Our Ref: 00 ULS St Edmunds Terrace 7 November 2024

Re: 12022/5392/P - Searle House & Benjamin House, Cecil Grove, London, NW8 7EB

DAYLIGHT & SUNLIGHT

Figure 1: ULS DLSL analysis model showing proposed condition & assessment scope

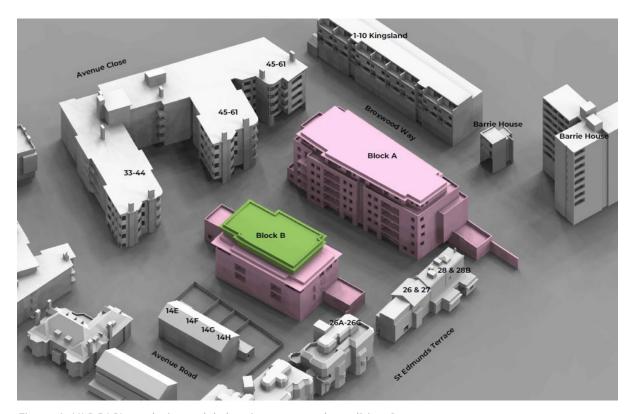
The ULS DLSL assessment analyses the impact of a new extension to block B vs the current DLSL values at the potentially affected neighbouring dwellings, as shown below.

Comparing the current and proposed VSC results for the houses at 14E-14H show between 0% (no change) and at most 1.73% VSC difference, an average of 0.8%VSC across the run of houses.

For 26&27 St Edmunds Terrace the VSC change is even smaller, ranging from 0% – 0.86%VSC at most, an average alteration of 0.4%VSC, i.e. extremely small.

Given the lack of any significant change from the baseline condition, the current extension has minimised the overall/ cumulative effect to its neighbours, in many cases having no effect at all to the baseline condition.
